# Access Compliance Report

## Public Rights-of-Way

### (Curb Ramps)

Intersection ID: 49008	Main Street: FARM_LN	Cross Street: STEELECROFT_PY	Location: SE
ADA ID: 531817DB6C96	Ramp Type: Perp	Initial Pass/Fail: Fail	Overall Compliance: No
Codes/Mitigation Info/Possible Solution		Field Measurements/Component Compliance	
Severity Score: 10

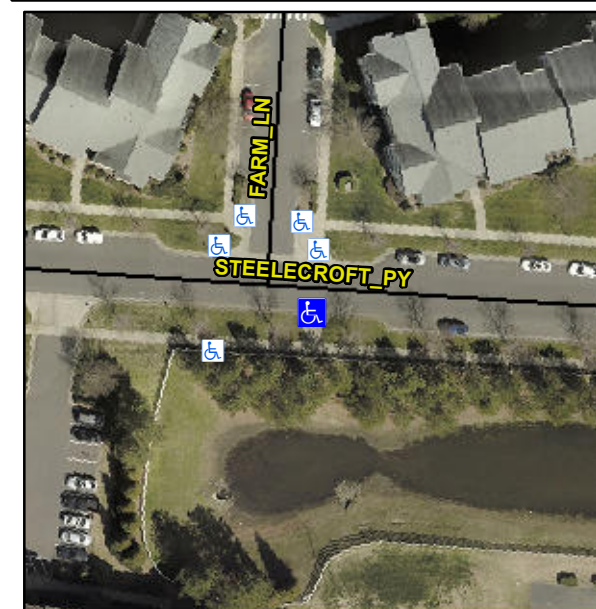
**Not Found, R304.5.1, R304.5.3**

Compliance	Description	Data	Compliance	Description	Data
N/A	Ramp Length (in)	84.0	Yes	Ramp Slope (%)	8.0
No	Ramp Width (in)	47.0	No	Ramp XSlope (%)	4.2
N/A	Flare Type LT	N/A	N/A	Flare Type RT	N/A
N/A	Flare Slope LT (%)	N/A	N/A	Flare Slope RT (%)	N/A
N/A	Flare Traversable LT?	N/A	N/A	Flare Traversable RT?	N/A
N/A	Landing Length (in)	N/A	N/A	DWS Provided?	N/A
N/A	Landing Width (in)	N/A	N/A	DWS Contrast?	N/A
N/A	Landing Slope (%)	N/A	N/A	DWS Length (in)	N/A
N/A	Landing X Slope (%)	N/A	N/A	DWS Full Width?	N/A
N/A	Landing Curb? (Y/N)	N/A	N/A	DWS Offset (in)	N/A
N/A	Shared Landing?	N/A			
N/A	Gutter Ponding?	N/A	N/A	Gutter Slope (%)	N/A
N/A	Gutter Lip Ht (in)	N/A	N/A	Gutter X Slope (%)	N/A
N/A	Painted X Walk1?	No	N/A	Painted X Walk2?	N/A
	X Walk 1 Direction	To N		X Walk 2 Direction	N/A
N/A	X Walk 1 Width (in)	N/A	N/A	X Walk 2 Width (in)	N/A
	X Walk 1 Slope (%)	2.9		X Walk 2 Slope (%)	N/A
	X Walk 1 X Slope (%)	0.9		X Walk 2 X Slope (%)	N/A

**Remove & Replace Entire Ramp.**
